SERVICE No. 1123B BULLETIN

Date: April 20, 2006 (M)

SB 1123A Service Bulletin superseded SB 413 and SB 1123 in their entirety. SB 1123B adds instructions for PA-34-200 aircraft, S/N 34-7250001 thru 34-7350135 without "Upstop" kit 760-699 installed and revises effectivities for the PA-34-220T Seneca V aircraft.

**SUBJECT: PA-34 SERIES AIRCRAFT NOSE GEAR
 INSPECTION AND PRODUCT IMPROVEMENTS**

Figure 1
 Trunnion Inspection
 (See Table 1, Item 3)

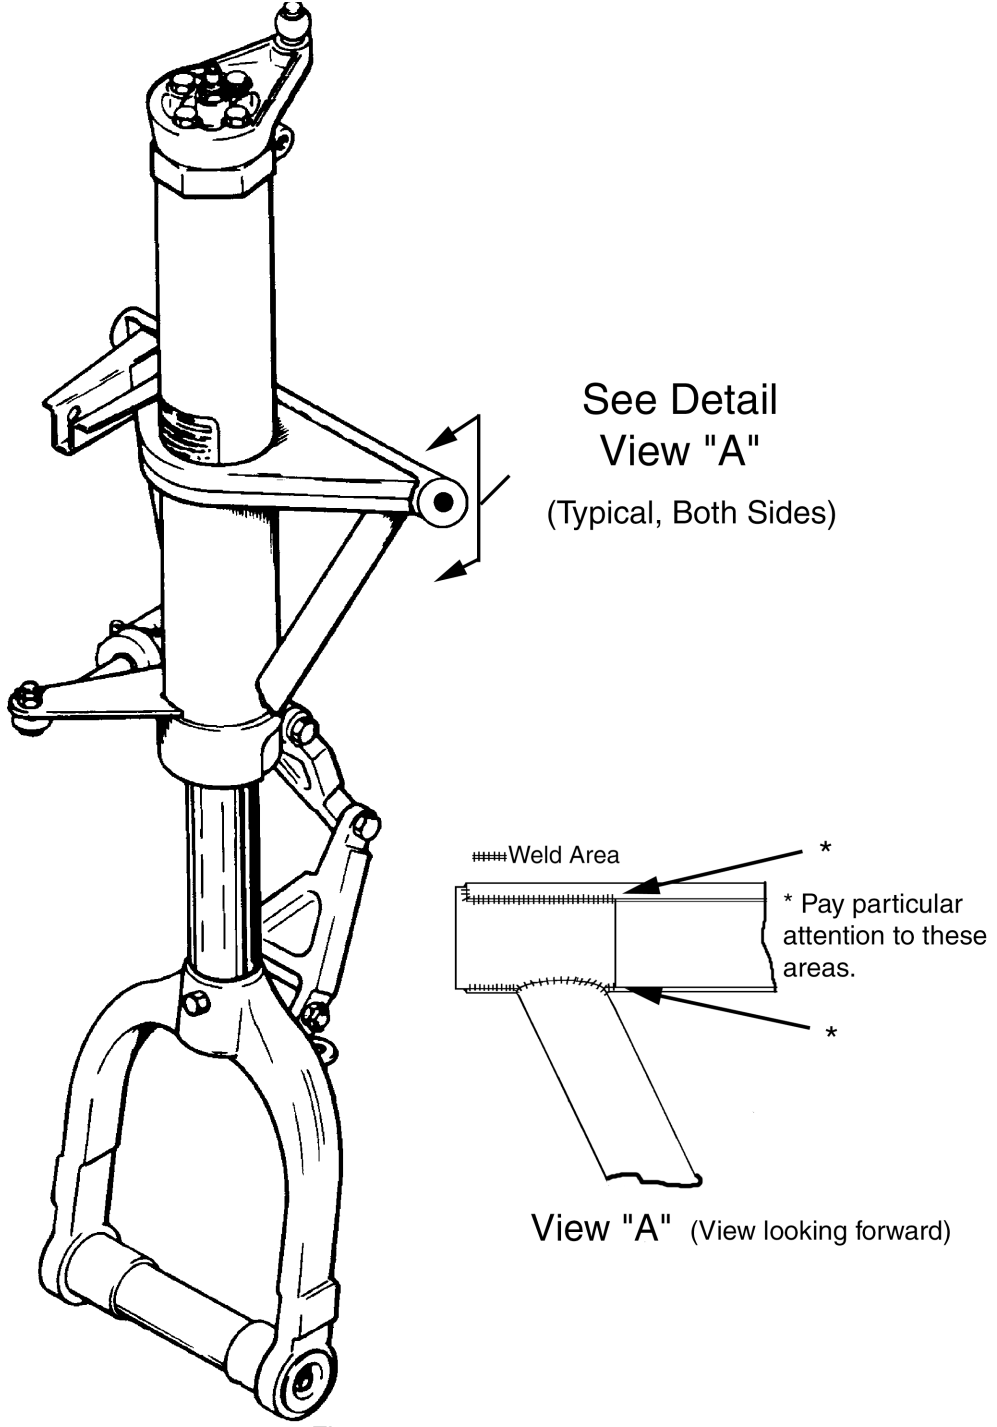
3. Visually inspect (2000 hrs. initial) the nose gear trunnion (P/N 95723-00, -05, -06) for cracks in the area of attachment to the nose gear mount assembly (See Figure 1) using supplemental lighting and a 10X magnifier				0

Figure 1A
Actuator Mounting Bracket Rivets

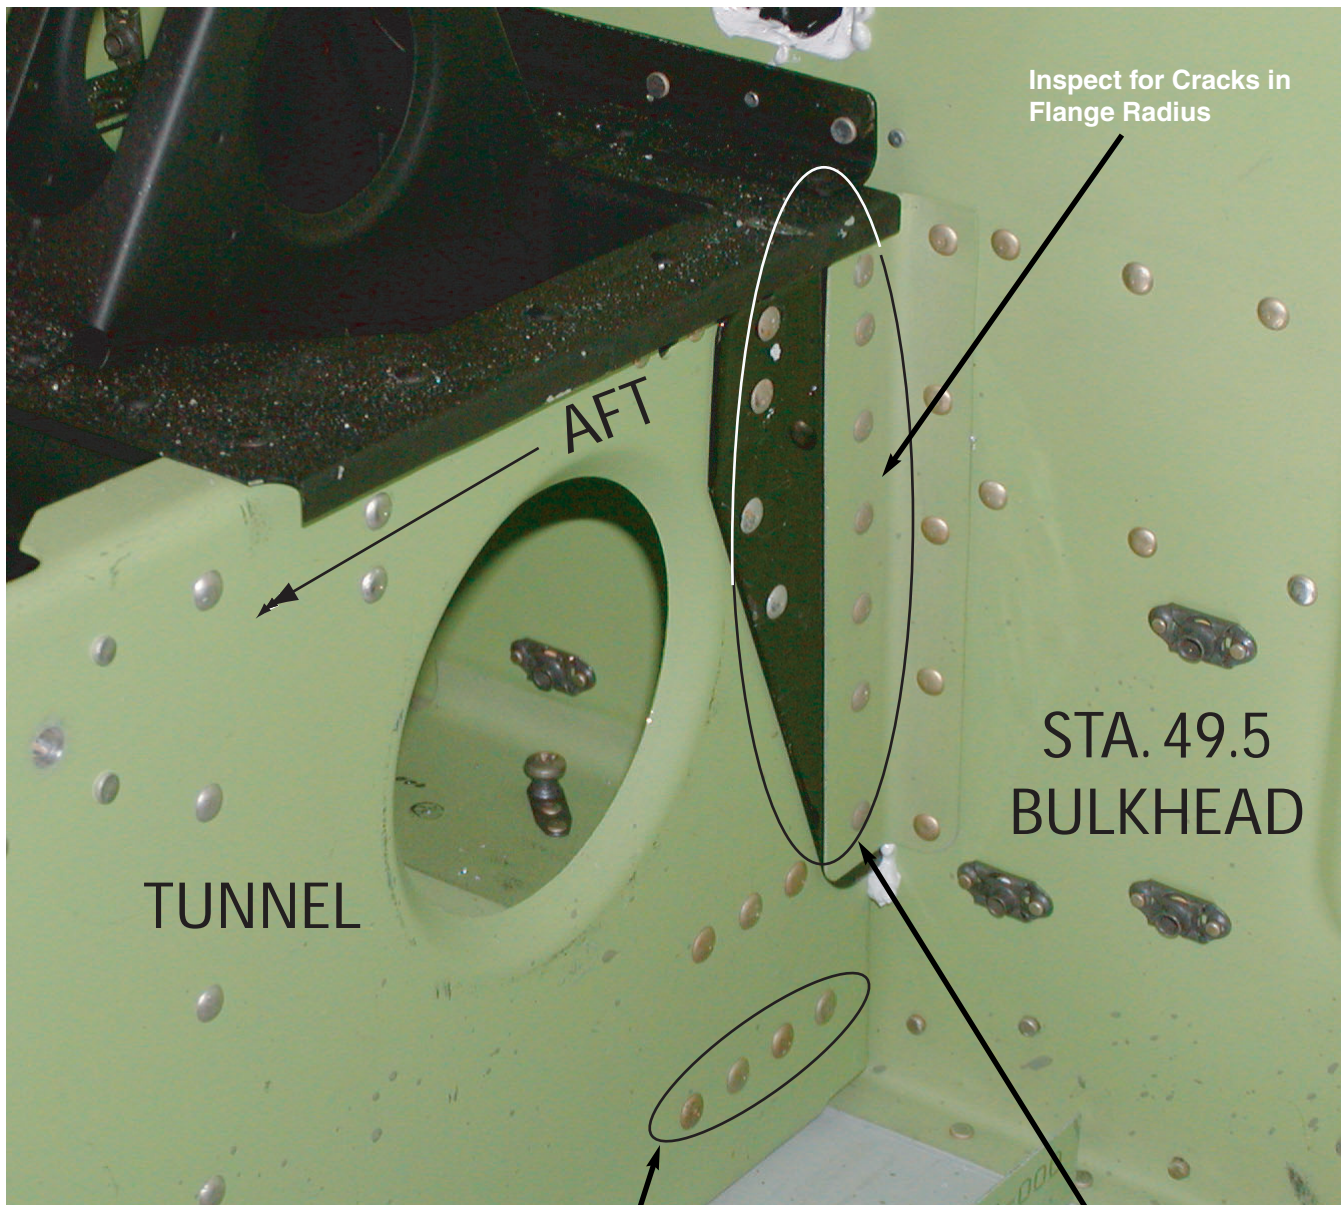
Inspect These (4 Rivets) for Attachment of Tunnel Bracket 95554-000.

Inspect These 11 Rivets

Inspect for loose mounting rivets that attach the actuator mounting bracket to tunnel aft of Sta. 49.5 bulkhead by placing aircraft on jacks, extend and retract landing gear and note any relative motion between the subject bracket and the tunnel. It will be necessary to pull carpet away from the side of tunnel to inspect noted rivets.

9. Inspect the actuator mounting bracket for cracks, elongation of the .250 dia. holes where the retraction link attaches, and for loose mounting rivets. (Reference Figure 1A for rivet inspection details) See paragraph 2. c. for aluminum -vs- steel mounting bracket inspections. See section 3 of this service bulletin for wear limits. See applicable S/N below. a. 34-7250001 through 34-7570050 b. 34-7570051 and Up For aircraft in category 9.a. that have had the steel mount bracket installed (95724-004 thru -007, as applicable), inspection requirements shall be per category 9.b.	0	0 0	0 0	0 0

<p>14. Inspect the Tunnel Bracket 95554-000 installation for loose attachment rivets to the tunnel and nose gear mount fitting 95555-000 and visually inspect for cracks in the bracket attachment flange adjacent to the fitting. This inspection can be accomplished through an access opening located in the bottom skin at B.L. 00.00, just aft of Sta. 49.5 bulkhead. Inspect for loose rivets by observing the area during the landing gear cycle test performed per Inspection No. 9. (Ref Figure 1A) and looking for any relative motion between riveted components.</p>		0	0	0
--	--	---	---	---

Figure 2
Service Wear Limit Locations

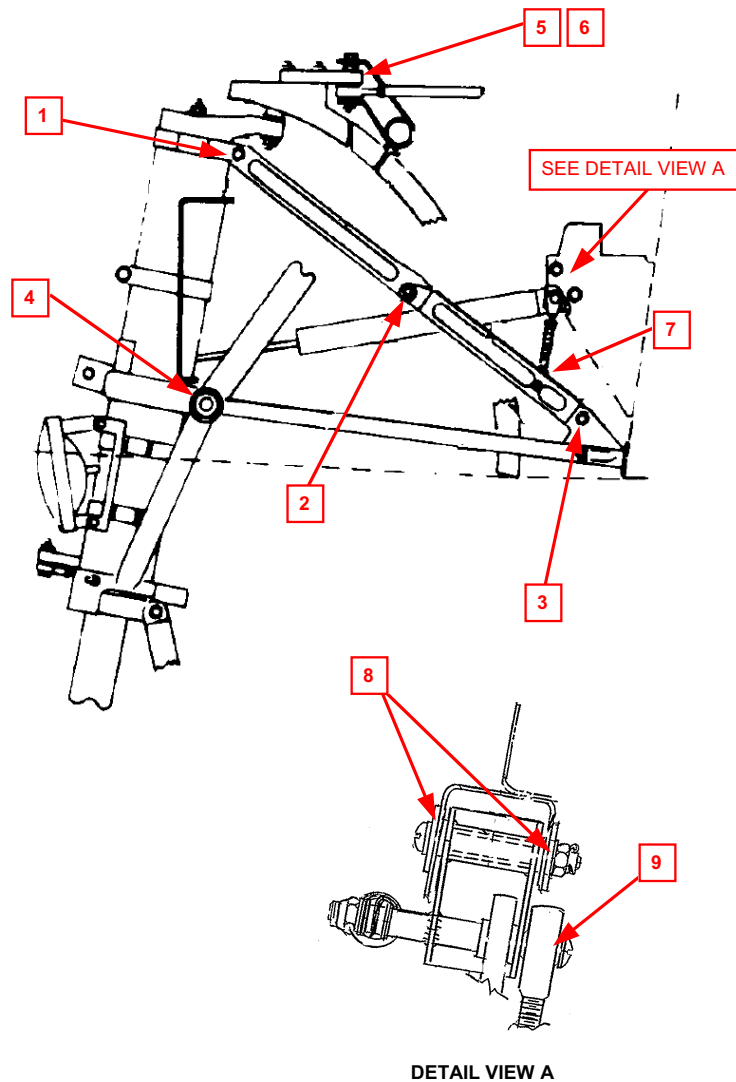
Table 3 is a "Wear Limits Chart" that can be used to determine the acceptable /or replacement condition for the listed parts that were inspected per Instructions Step 1. in this Service Bulletin. Visually inspect all bolts/pins for wear, damage, or corrosion. Replace as required.

Part Description		ID Wear Limits		Part Description		ID Wear Limits	
		Min.	Max.			Min.	Max.
1.	Drag Link Upper Bushing	0.562	0.564	6.	Steering Arm Center Pivot Sleeve	0.250	0.253
2.	Drag Link Center Bushing	0.375	0.377	7.	Down Lock Link Bushing	0.251	0.253
3.	Drag Link Lower Bushing	0.438	0.442	8.	Actuator Mount Bracket	0.250	0.252
4.	Trunnion Pivot Bushings	0.500	0.503	9.	Down Lock Link Rod End	0.190	0.192
5.	Steering Arm Center Pivot Bushings	0.375	0.377

Figure 3
Drag Link Over-Center Measurement
Nose Gear Installation

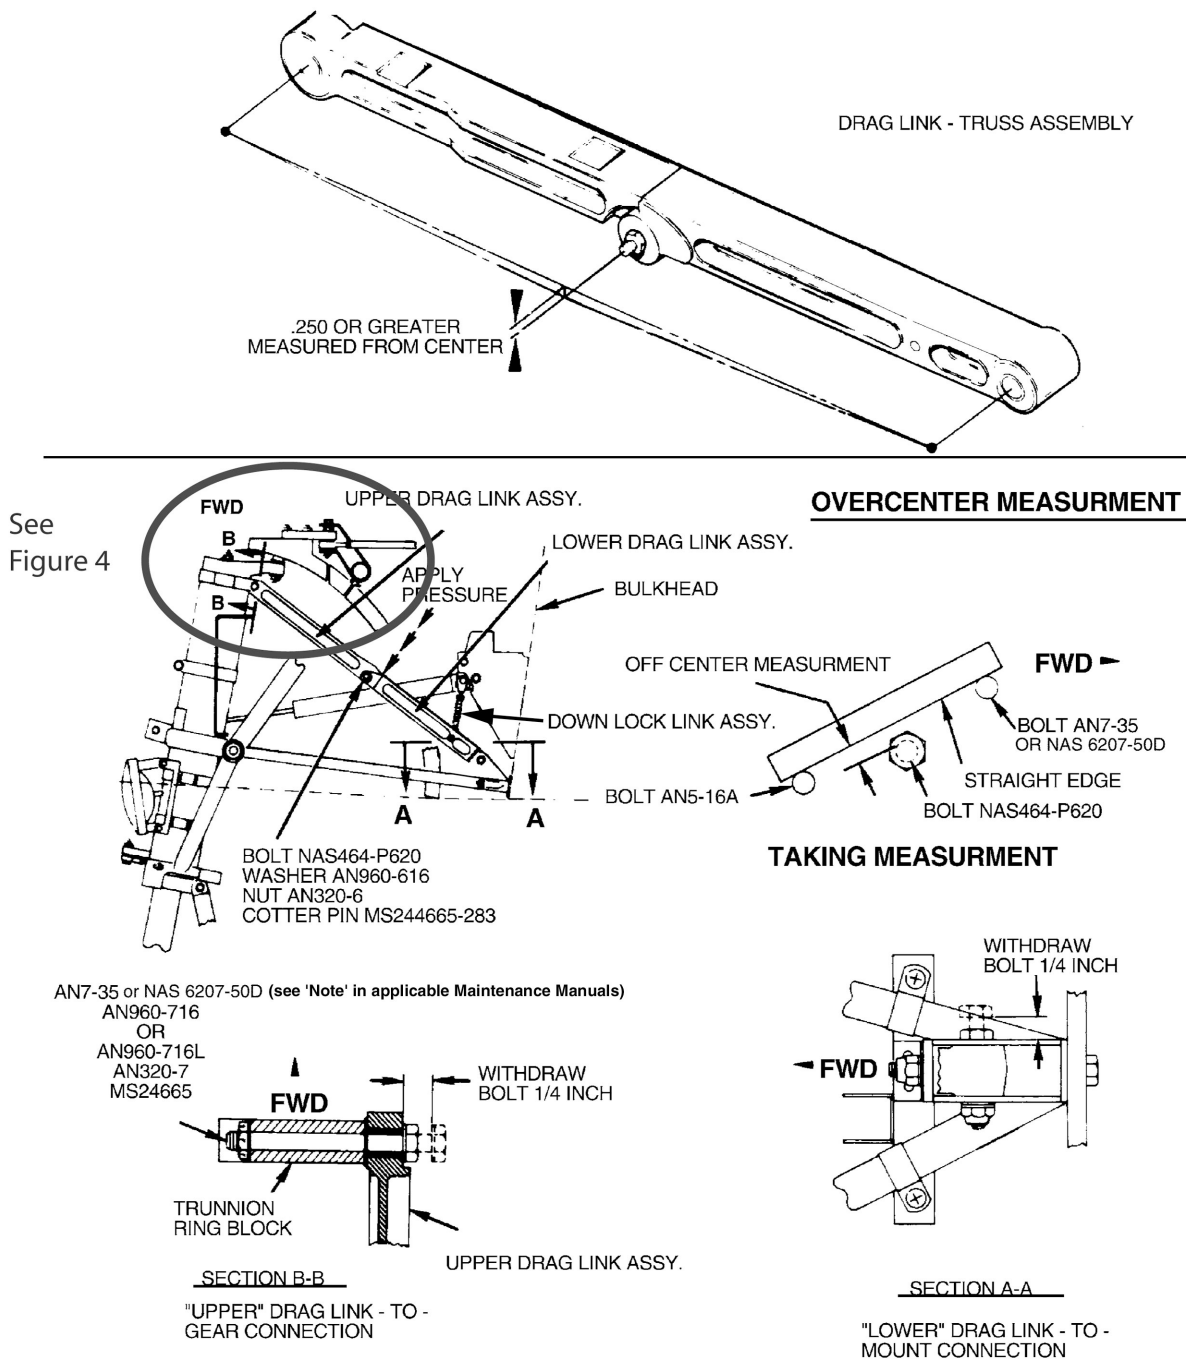
- a. For Senecas serial numbers 34-7250001 through 34-7450220: Rigging of the nose gear installation (Item 13, Table 1) shall be accomplished per this Service Bulletin. The 'over center' measurement for the Seneca, as for all Senecas, shall be 0.250 or greater as measured from the center (See Figure 3). The Service Manual will be revised to delete reference to Service Bulletin 413. All required measurements are in this service bulletin and will be incorporated into the Service Manual.

- b. For Senecas II through V: Rigging of the nose gear installation (Item 13, Table 1) shall be accomplished per the appropriate Service Manual with the following exception for the Seneca II. The 'over center' measurement for the Seneca II, as for all Senecas, shall be 0.250 or greater as measured from the center (See Figure 3). The 0.250 dimension supersedes the 0.300 dimension which was incorrectly stated in the Seneca II Maintenance Manual. Refer to the Maintenance Manual for the procedure to make the over center measurement. This Service Bulletin supersedes Service Bulletin No. 413, Nose gear Drag Link Dimension Check.

Figure 3A
Nose Gear Installation

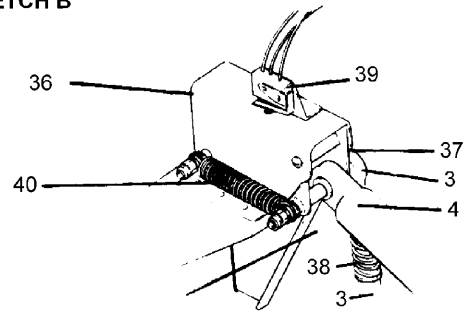
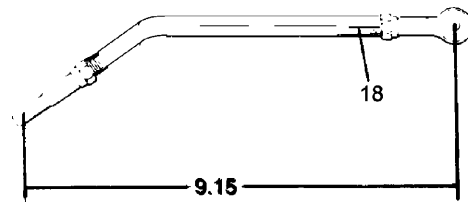
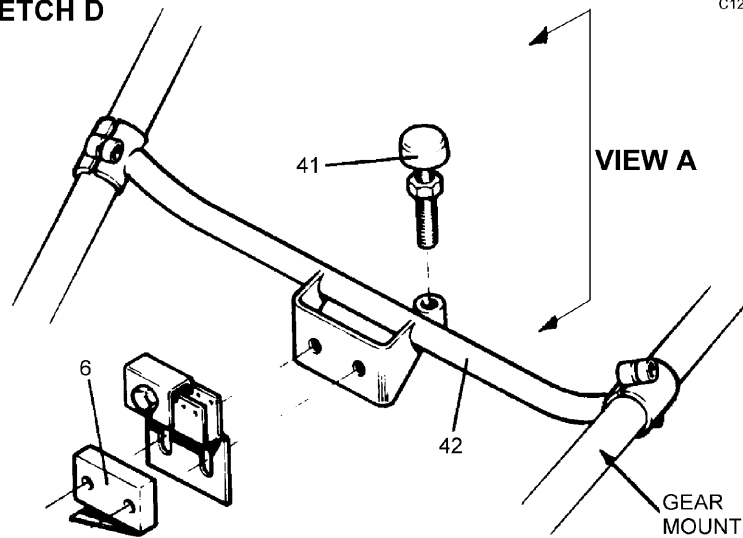
NOTE: Upstop NOT installed on PA-34-200 aircraft S/N 34-7250001 through 34-7350135 unless Kit 760-699 has been complied with.

- e. At the actuator housing attachment assembly (see Sketch B, Figure 3A), disconnect the retention spring from the retraction link fitting.
- f. Position the gear in its down locked position and check that the drag links have fully extended to their through center position with the stop surfaces in contact.

Figure 4
Steering Arm Channel Clearance

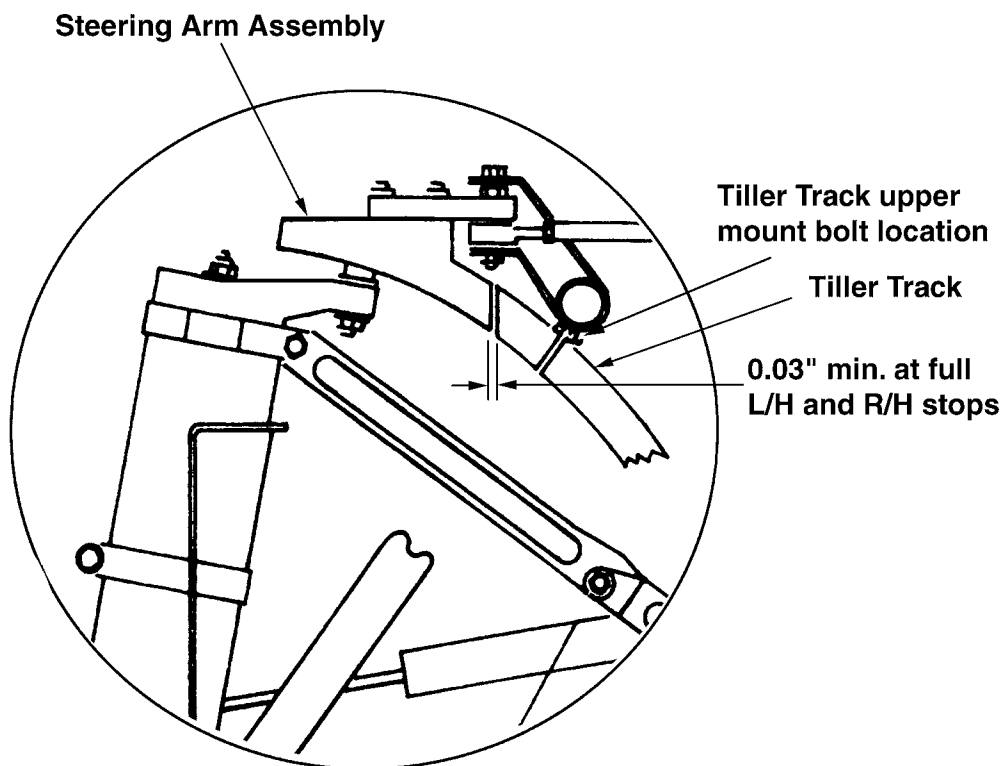
- a. Turn the nose gear full travel and make sure the clearance between the steering arm assembly and the tiller track is a minimum 0.03 of an inch at both the left and right stops. (see Figure 4). If insufficient clearance is obtained, loosen the upper mounting bolts for the tiller track and move the track upwards in the slotted holes where the track is attached to the gear mount assembly. Adjust to obtain a minimum clearance of 0.03 of an inch. Tighten the upper mounting bolts.
